**Re: Case No. 21-4-EL-BGN**

In the Matter of the Application of Tymochtee Solar, LLC for a Certificate of Environmental Compatibility and Public Need to Construct a Solar-Powered Electric Generation Facility in Wyandot County, Ohio

**Third Supplement to Application – Facility Layout – Updated Figure 3-2**

**Reference:** Inverter Adjustment and Panel Removal

Figure 03-2. Facility Overview

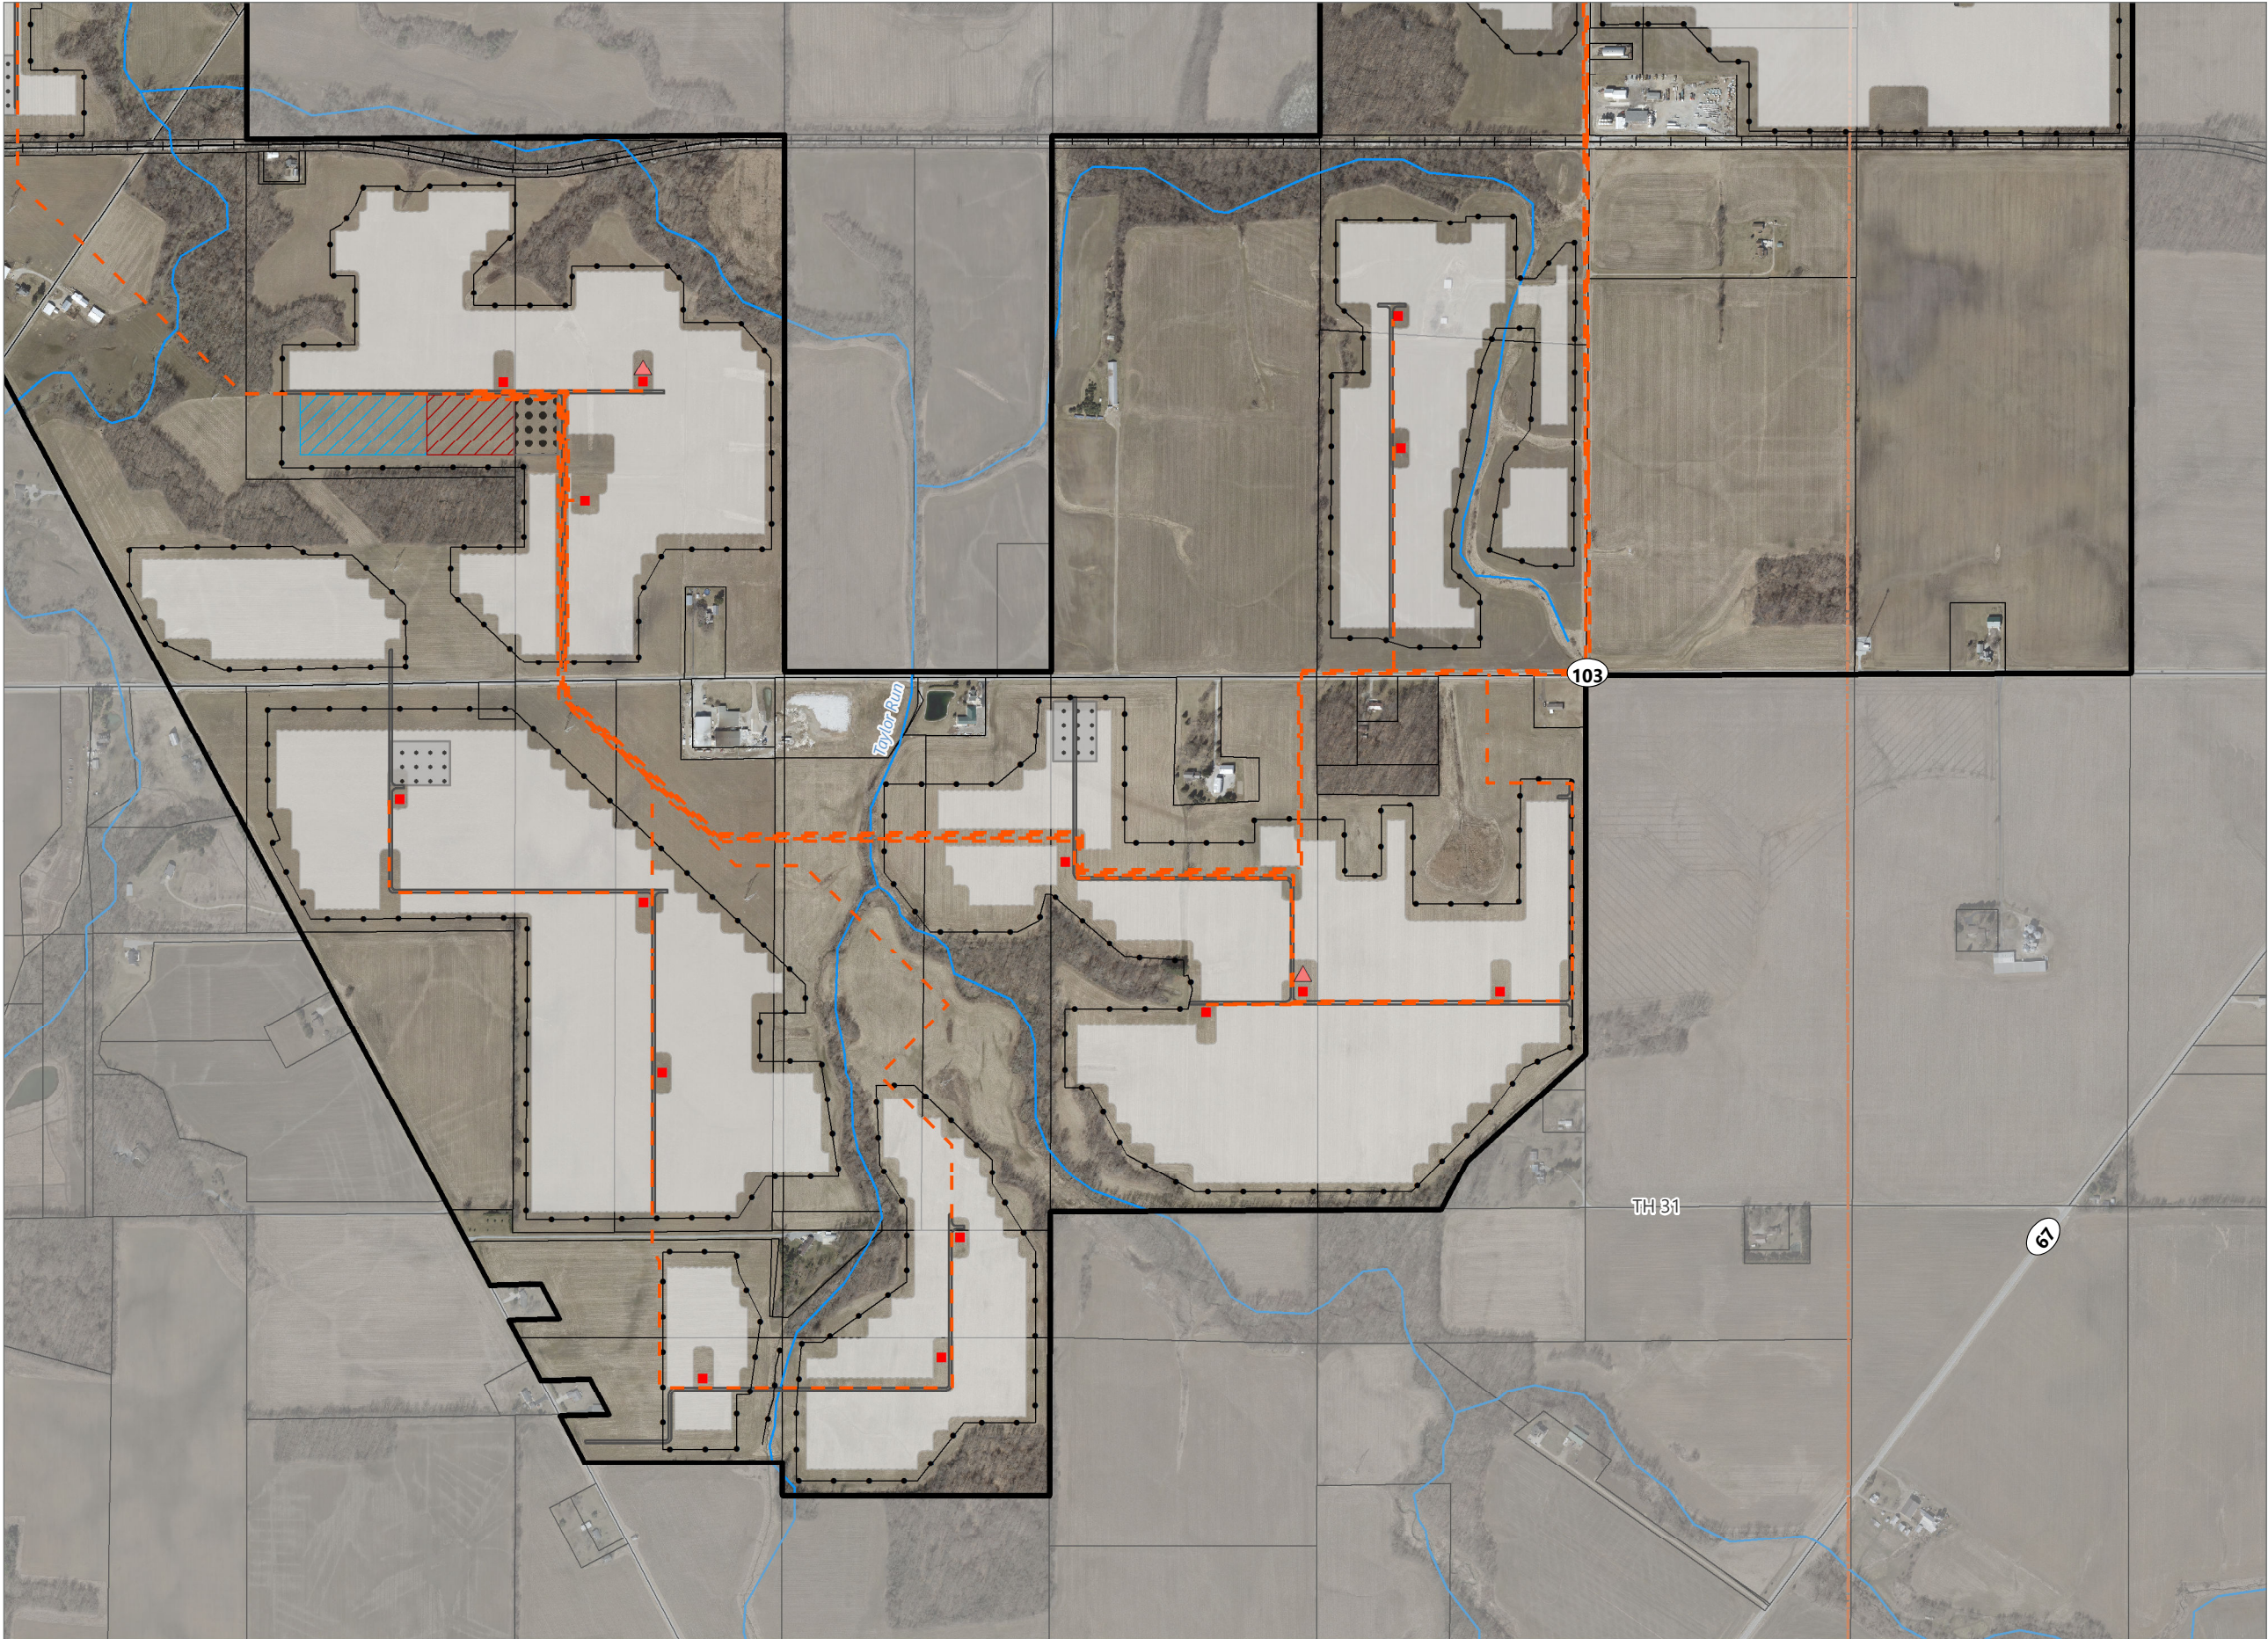
Additionally, to address feedback from Ohio's State Historic Preservation Office, panel arrays were removed at two locations, which are shown on sheets 2 and 3 of the attached Figure 3-2 Facility Overview with Highlighted Adjustments map. These adjustments are also included on the attached Facility Overview clean version of the updated Figure 03-2 map.

**FIGURE 1: SOUND MODELING RESULTS FOR CURRENT LAYOUT, DAYTIME**

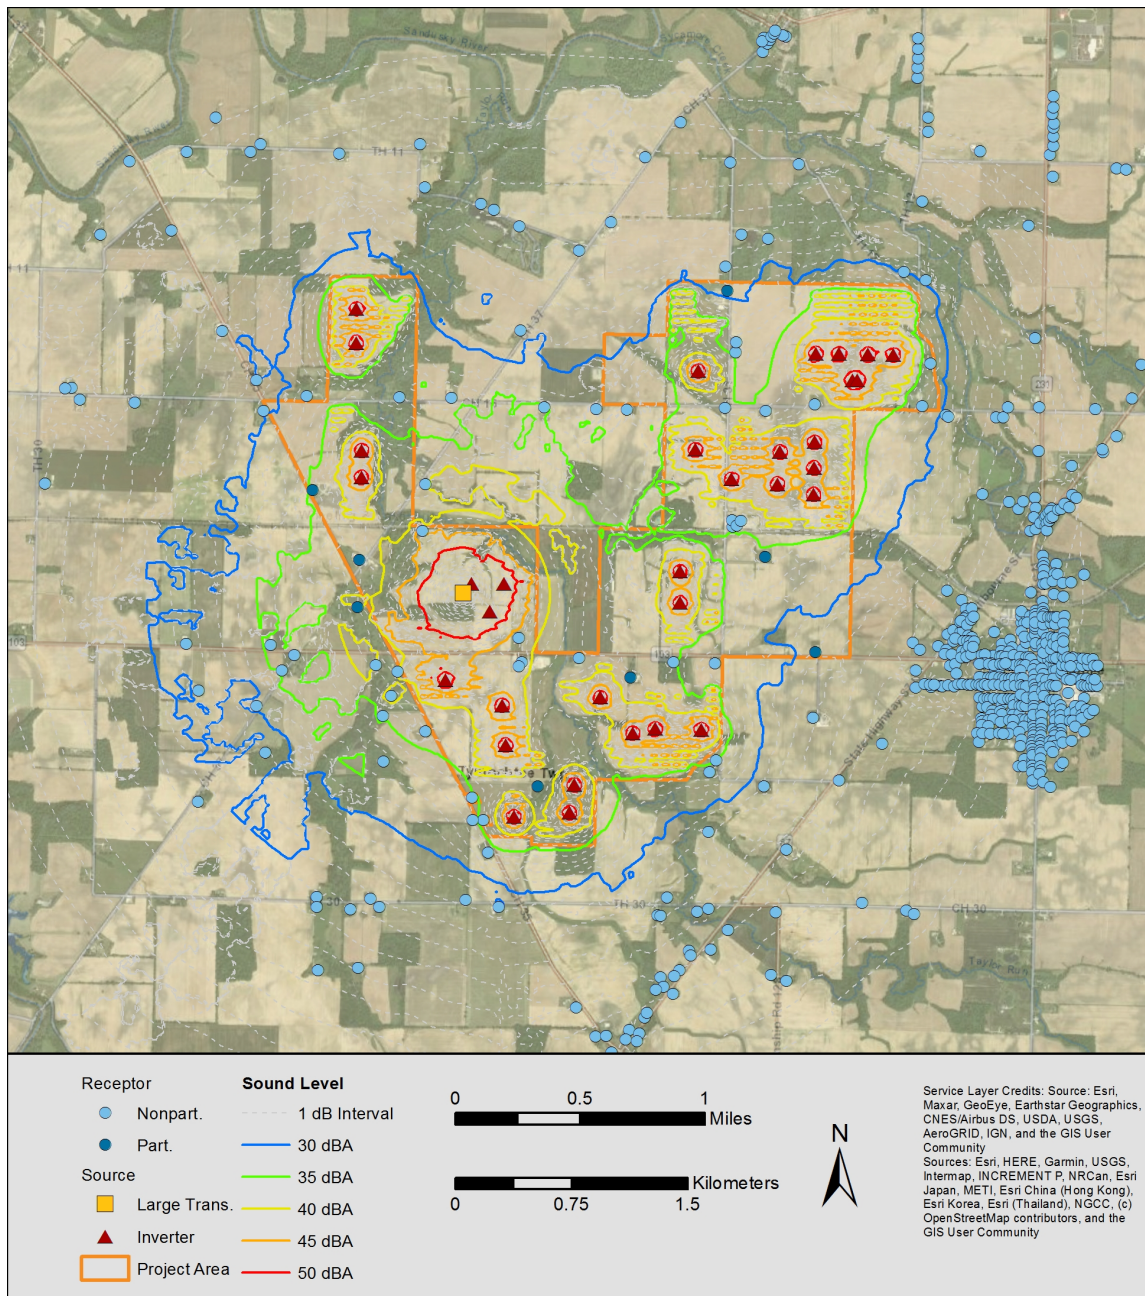
Sound contour maps for the current layout are provided in Figures 1 and 2 during the daytime and nighttime periods, respectively.
